AMENDMENT OF SOLICITATION/MODIFICATION OF CONTRACT			1. CONTRACT ID CODE N/A		PAGE OF PAGES 1 70
6 ICCLIED BY	3. EFFECTIVE DATE SEP. 03, 2004	4. REQUISITION/PURCHAS N/A		SPEC. 1	NO. (If applicable) NO. 1406
DEPARTMENT OF THE ARMY U.S. ARMY ENGINEER DISTRICT, SACR SACRAMENTO, CALIFORNIA 95814-2922	7. ADMINISTERED BY (If other than Item 6) DEPARTMENT OF THE ARMY U.S. ARMY ENGINEER DISTRICT, SACRAMENTO SACRAMENTO, CALIFORNIA 95814-2922

14. DESCRIPTION OF AMENDMENT/MODIFICATION (O. California Army National Guard (CAARNG) Readiness Center Lancaster, California	0 - 2	s, including solicitation/contrac	t subject matter where fe	asible.)	
2 Encl.					
 Revised Pages: List of Drawing and Specing 02230-1,02260-1,02300-1,02300-3,0274 09310-3,09511-4,09511-5,09680-1,09912 Revised Drawings: T000, C101, C102, C103 S302,S303,S306,S410,S412,S413,S414,S414 	1-8,02751-6,033000-4, 2-2,10200-3,10505-6,1 ,C110,A004,A005,A2	03470-3,05310-1,0811 5515-6,15839-2,15839 12,S100,S101,S110,S1	(0-3,08331-5,084) 9-3,15900-3,15900 111,S211,S220,S2	11-4,09260- 0-5	3,09310-2,
Except as provided herein, all terms and conditions of th and effect.	e document referenced in Ite	m 9A or 10A, as heretofore	changed, remain

Drawing No. **S101**

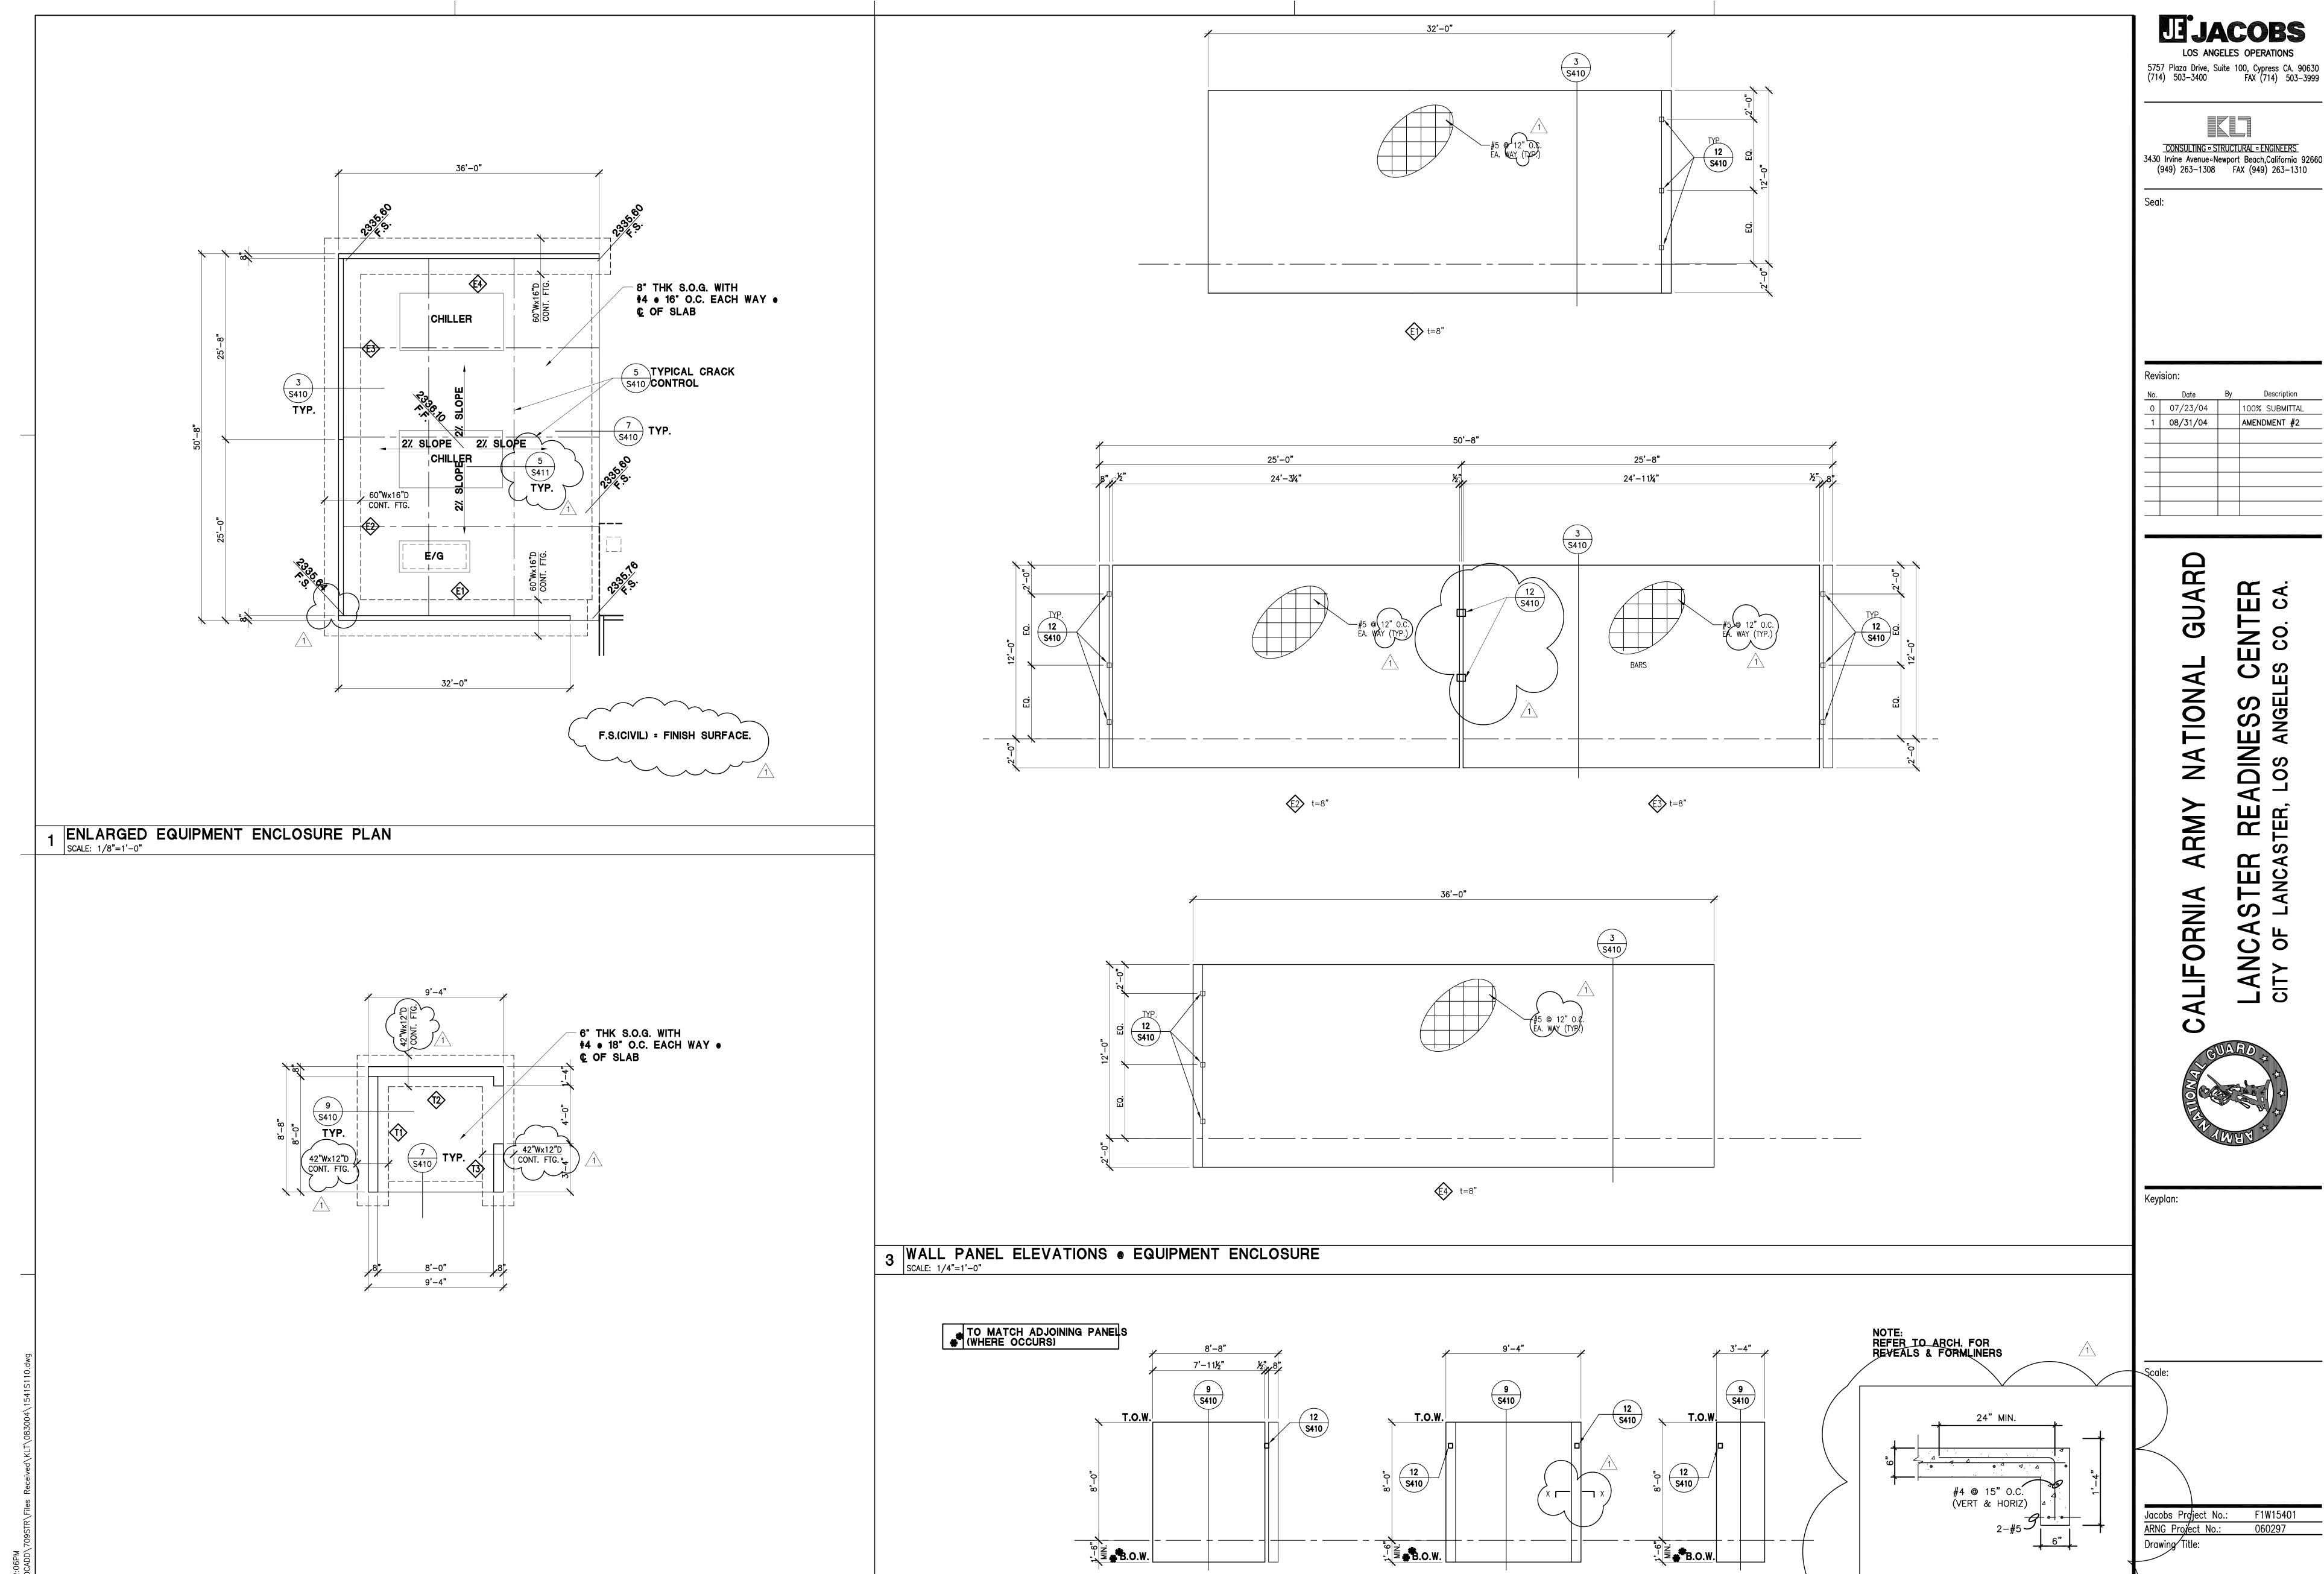
Sheet	Drawing Title	Summary of Changes
S100	General Notes	Added reinforced concrete note # 16; Deleted structural and misc. steel note # 17; revised precast conc. Panels note #12; revised metal building note #1
S101	Abbreviations and Legends	Deleted moment connection symbol
S110	Enlarged Site Foundation Plans and Panel Elevations	Revised detail callouts and added section x-x on detail 5
S111	Canopies Framing Plans and Details	Revised details # 1, 4, 6, 7, 8, 10 and 11
S211	Storage Building Foundation Plan	Revised plan A notes and detail # 2; Revised foundation notes # 1
S220	Overall Second Floor Framing Plan	Revised detail callouts; added note on steel deck; revised framing note # 5; Deleted note C
S230	Overall Low Roof Framing Plan	Deleted metal deck note D, roof framing note D; and 9; revised # 10 to new # 9; revised truss to beam at column grid E near column grid 3
S240	Overall High Roof Framing Plan	Deleted metal deck note E, roof framing note # 9; revised note D and # 7; revised misc. notes on framing plan; added subframing on plan

PARTIAL HIGH ROOF FRAMING PLAN

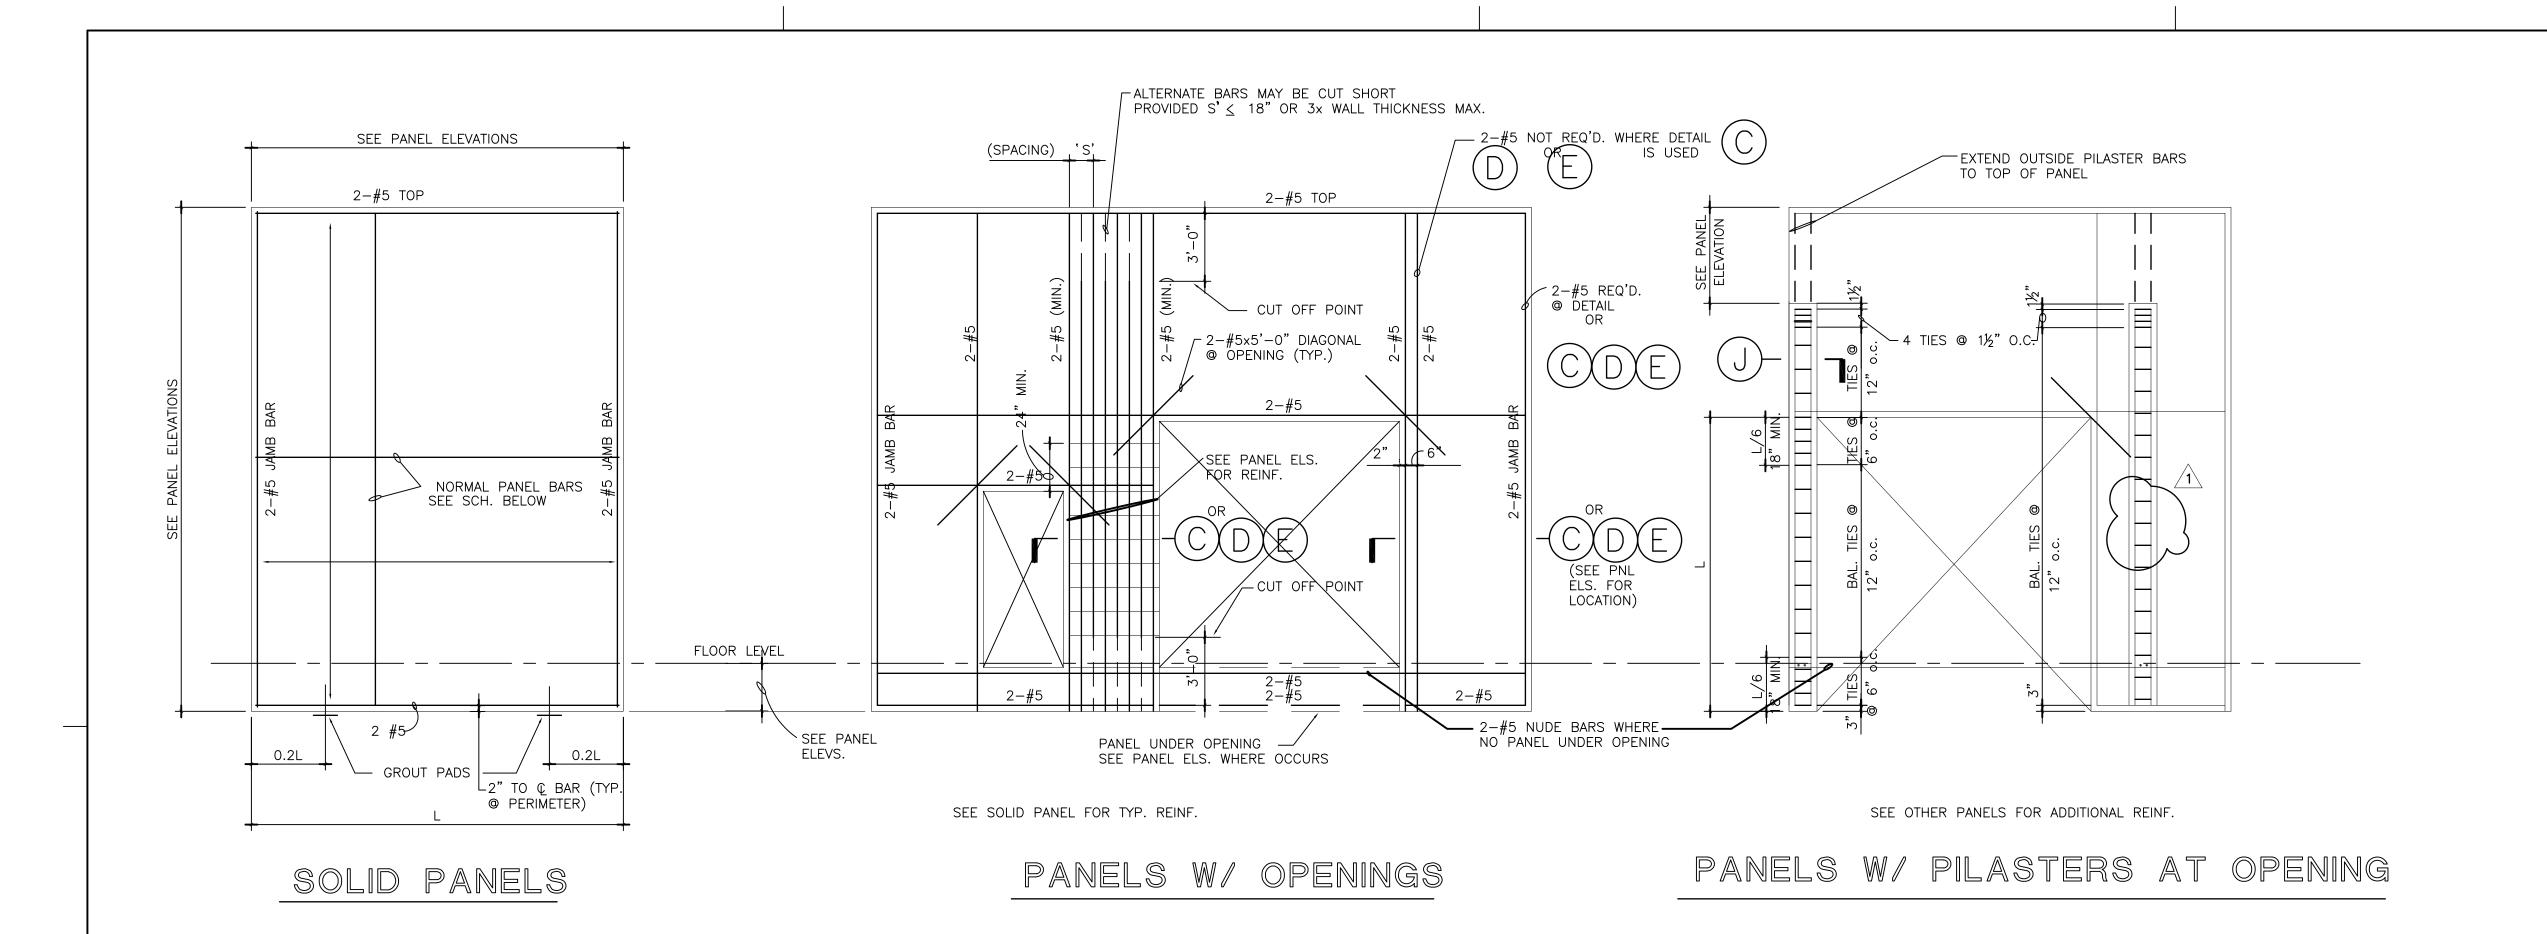
S250	Enlarged Partial High Roof Framing Plan	Deleted note C and 5 Renumbered 6 to 5
S300	Typical Wall Panel Details	Added note # 14; deleted detail H callout
S301	Wall Panel Elevation	C12 notated at panel 2 elevation; Added panel 25 connection
